# **GUSTIN ADDITION TO JACKSON STREET**

## **SUBDIVISION**

APPLICATION NUMBER 14 DATE December 18, 2003

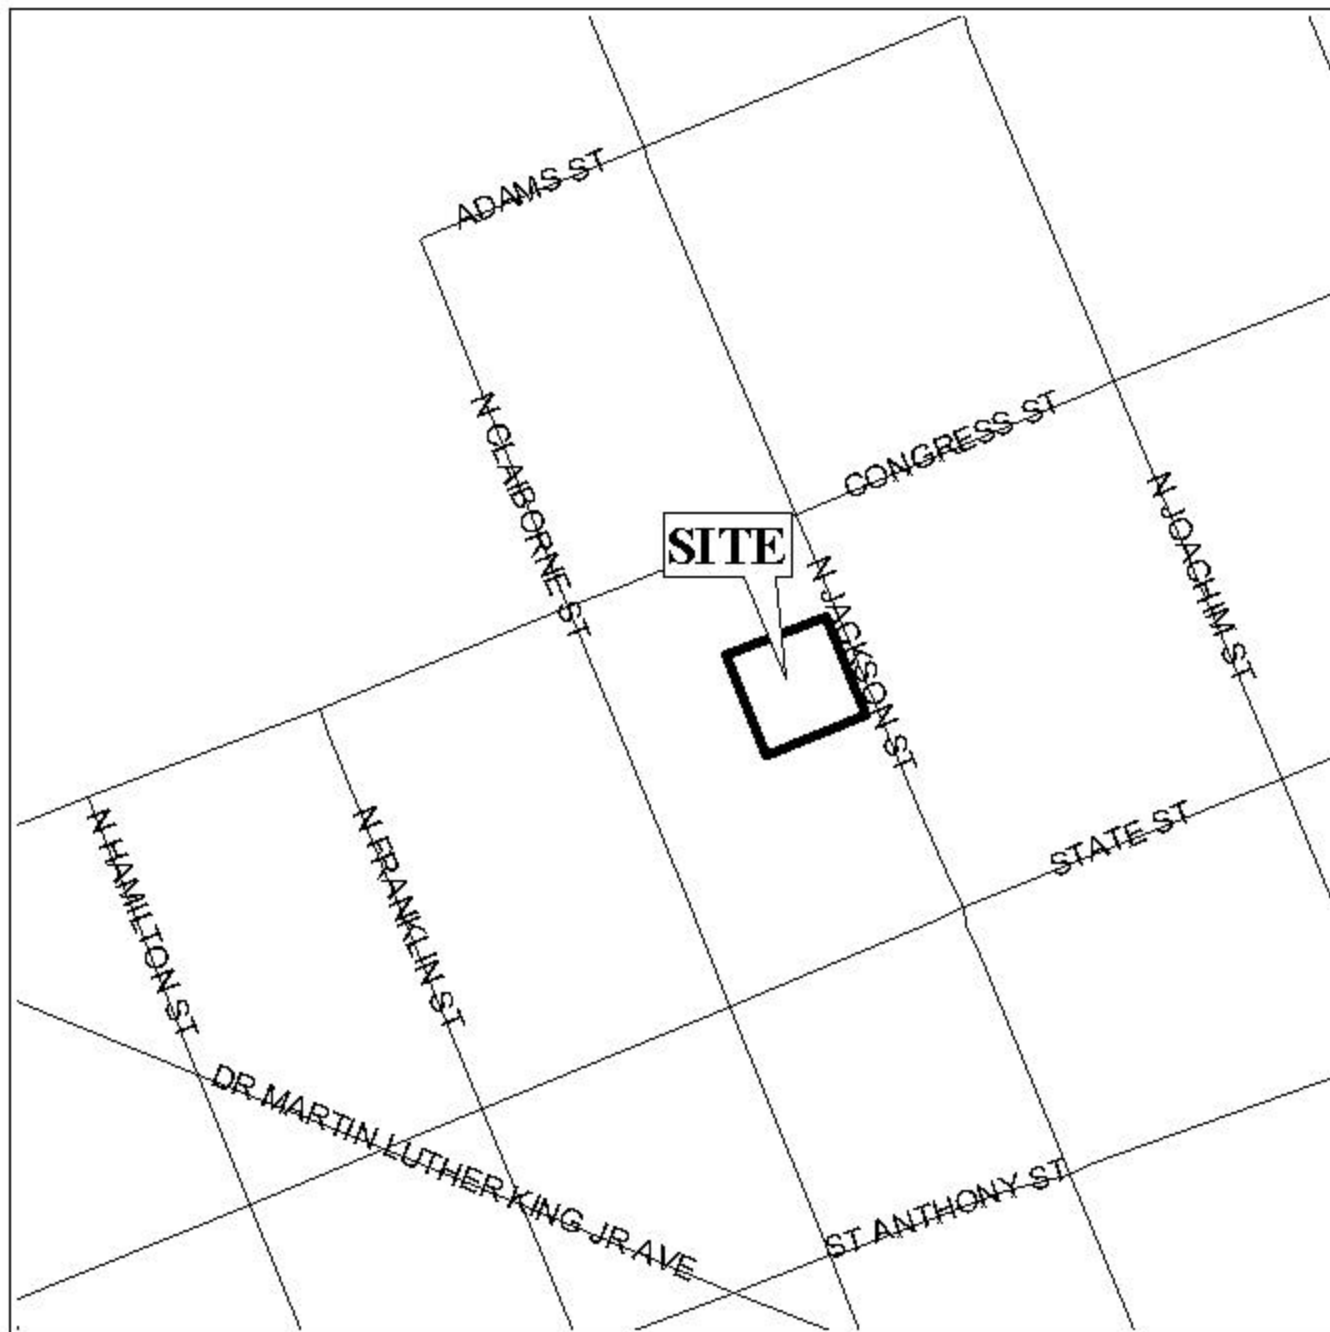
Engineering Comments: Must comply with all stormwater and flood control ordinances. Any work performed in the right-of-way will require a right-of-way permit.

Traffic Engineering Comments: Driveway numbers, size, location and design to be approved by Traffic Engineering and conform to AASHTO standards.

The two lots share access and parking; therefore, the submission and approval of an Administrative Planned Unit Development would be required.

The site is located downtown and many of the small lots are nonconforming and as proposed Lot 1 would have 5,195 square feet of area. In R-B districts, there is no minimum area requirement for building sites; therefore, a waiver of Section V.D.2. would be both required and recommended for the proposed lot.

The Zoning Ordinance allows a 5' front yard setback in R-B districts and due to the historic nature (De Tonti Historic District) of the neighborhood. A waiver of V.D.9. would be required to reduce the 25-foot setback to 5-feet as allowed by the Zoning Ordinance.

With a waiver of Sections V.D.2. and V.D.9., the plat will meet the minimum requirements of the Subdivision Regulations and is recommended for Tentative Approval subject to the following conditions: 1) the placement of a 5-foot setback line along the street frontage; and 2) the submission of an Administrative PUD for the shared access and parking.
